Keystone RV Company

SAFETY ADVISORY # 18-314

Zinger/Longhorn GFCI Ground Wire

**Fig. 2****Step 3**

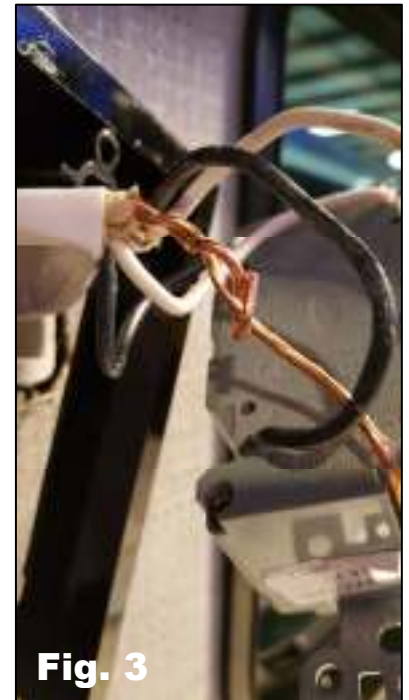
Remove the receptacle and inspect the bare copper ground wires for proper installation, Figure 2. There should be a copper crimp connector that crimps the ground wires together.

If there is a copper crimp connector, as in Figure 2, attached to the bare copper wires, proceed to Warranty Reimbursement. If not continue to step 5.

If there is no copper crimp connector (see Figure 3), remove the wire from the GFCI receptacle and install an approved connector as listed under the “Parts Required” section above. Reattach the ground wire to the GFCI receptacle and install the GFCI receptacle in receptacle box. Proceed to Warranty Reimbursement.
